**LEGAL ADVERTISEMENT
PORTLAND PLANNING BOARD MEETING**

AGENDA PORTLAND PLANNING BOARD

Planning and Urban Development Department

Filename: 020_FireProtection.dgn

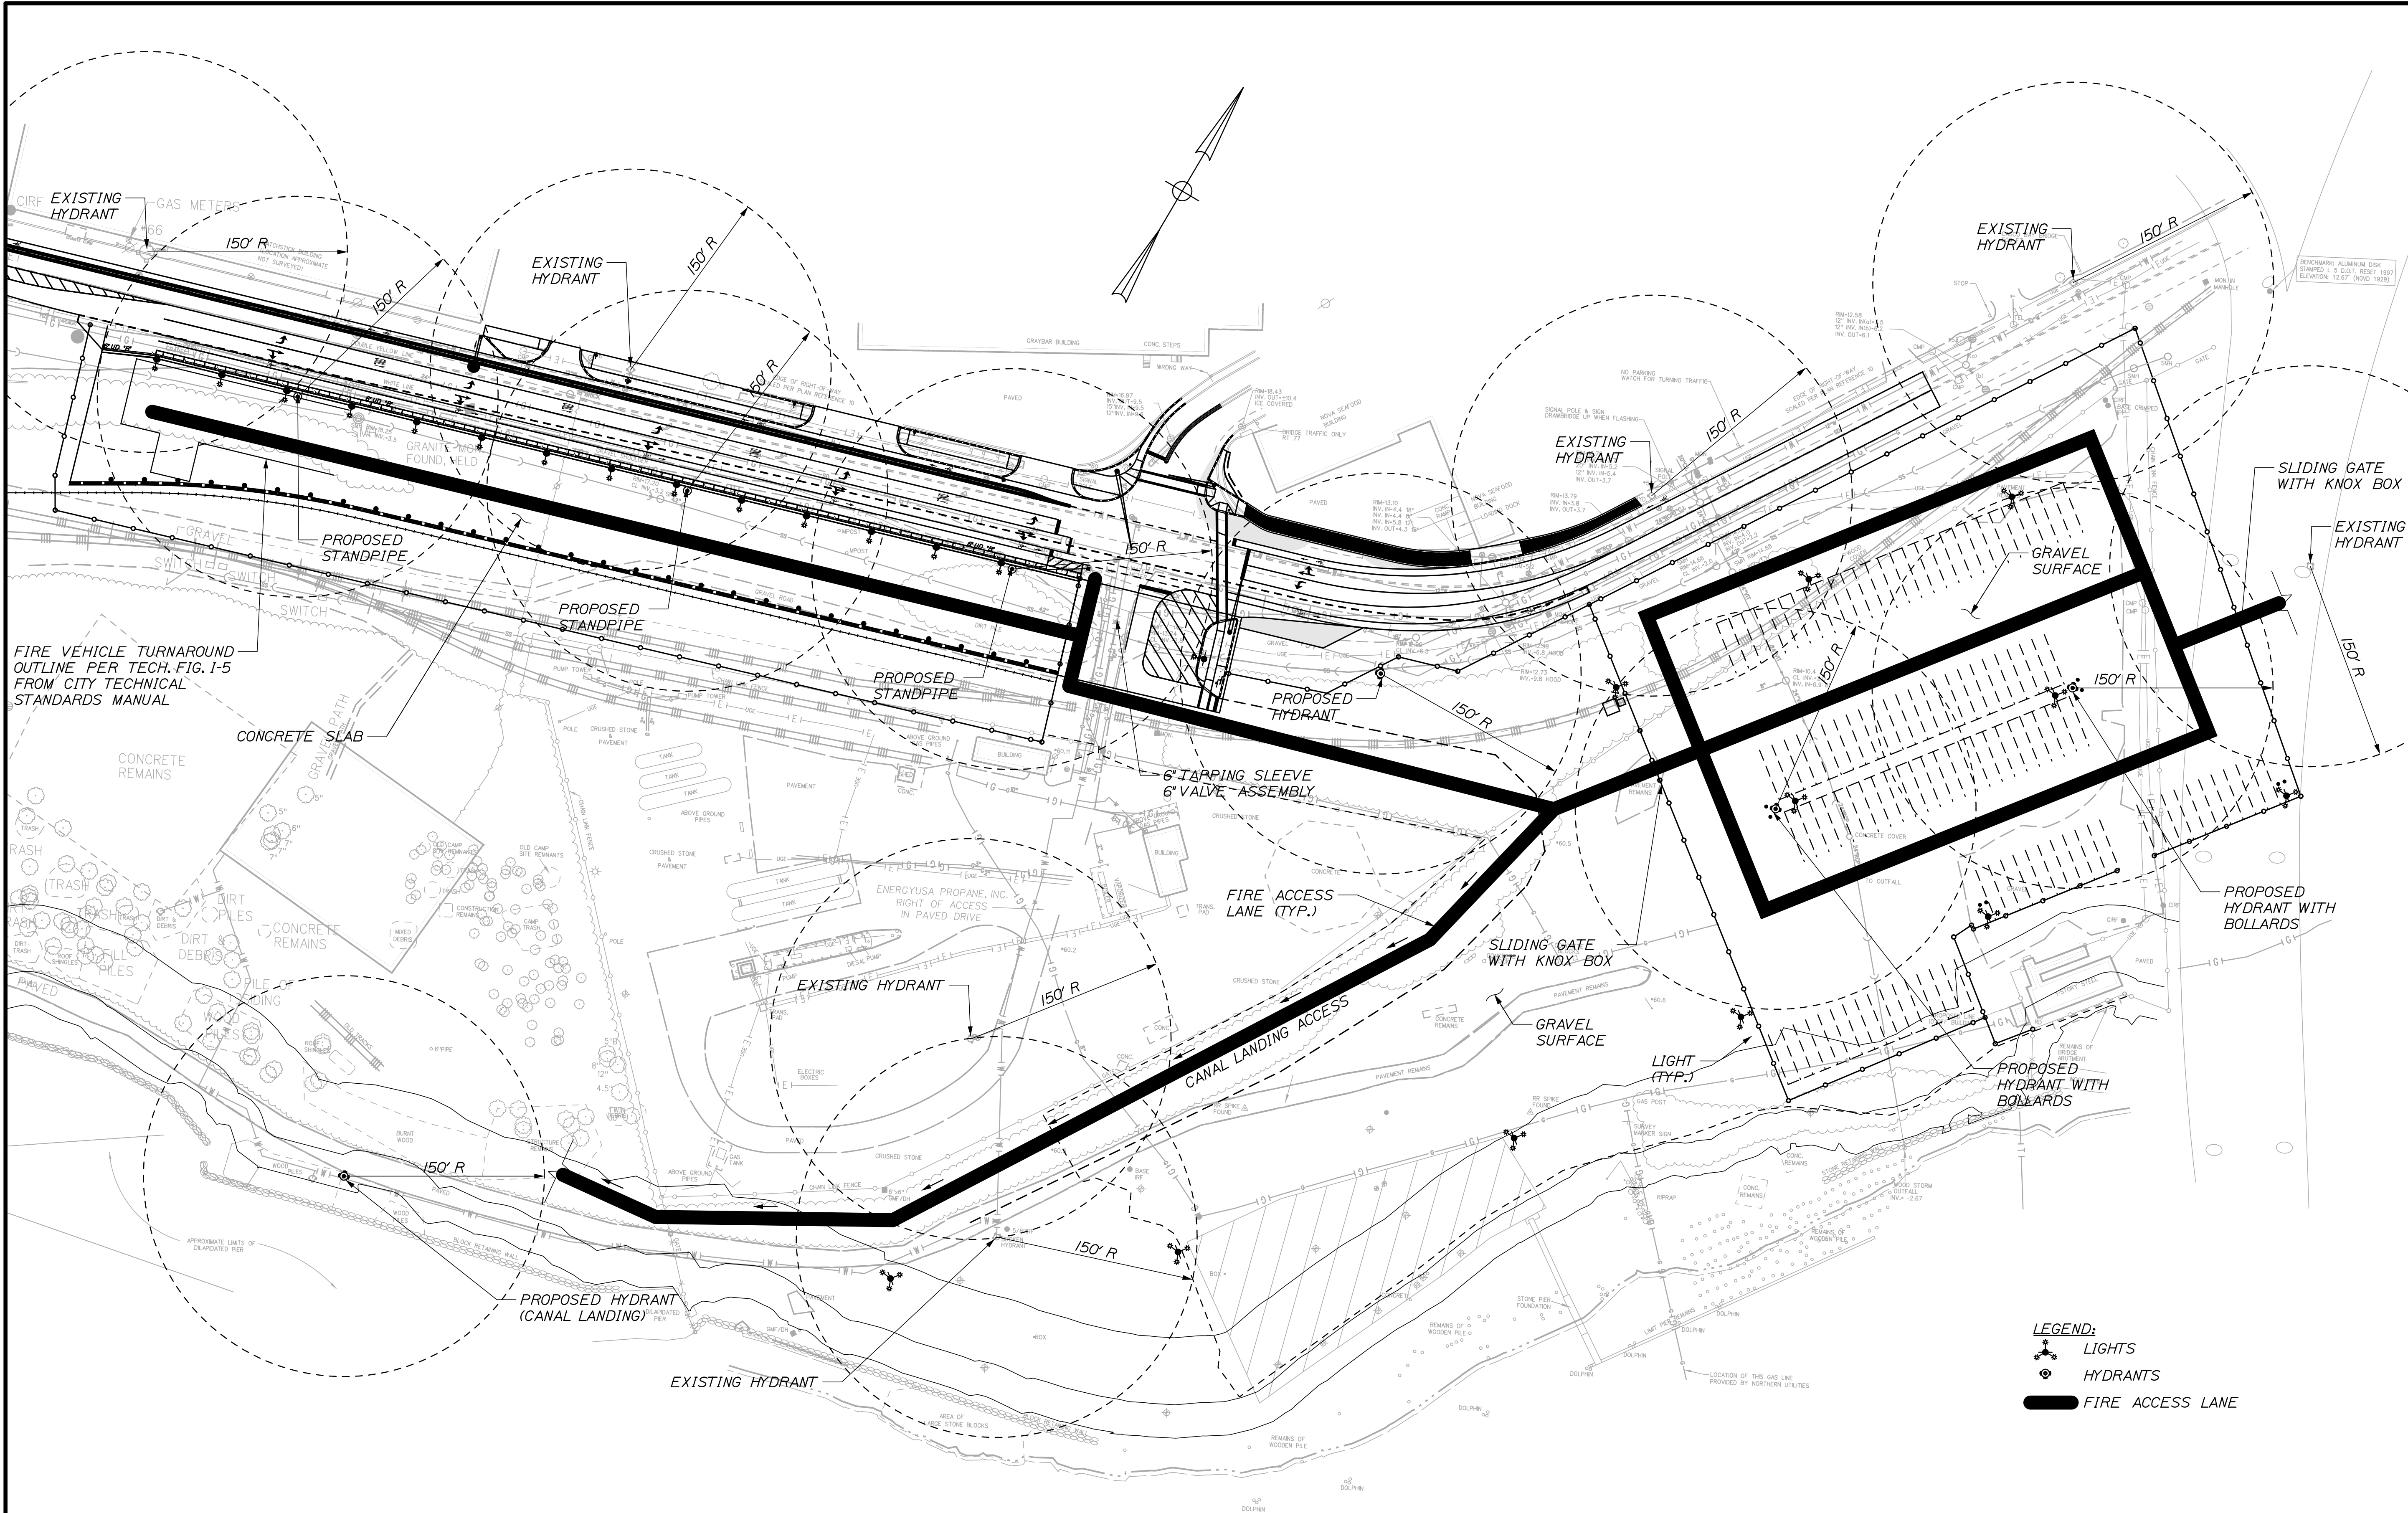
from Commercial Street. The proposed hydrant and standpipe locations throughout the expanded IMT site are depicted on the proposed site Fire Protection Plan; drawing C17. Due to the fact that the standpipes will be exposed to freezing temperatures, it is recommended that the standpipe section of the fire water supply system be supplied from a single post indicator valve (PIV), located adjacent to the access point to the loading area. To allow the fire department flexibility in connecting to the individual standpipes after the this portion of the system has been pressurized, it is recommended that each standpipe riser be provided with an isolation valve that will facilitate connection to the individual fire department connections after the PIV has been opened.

1. Install sufficient numbers of fire hydrants and standpipe connections throughout the expanded IMT site to provide adequate access to firefighting water for the Fire Department. The Fire Protection Plan (Dwg C17) should be updated to include the location for a PIV to isolate the standpipe section of the water supply piping. It is understood that the codes do not specifically discuss the use of standpipes in lieu of fire hydrants. However, due to the area restrictions within the railway loading area, coupled with a desire to ensure that no damage occurs to the fire water supply access points (hydrants), this design represents the likely best option to facilitate that goal. However, it will be necessary to obtain input from the fire department to ascertain the
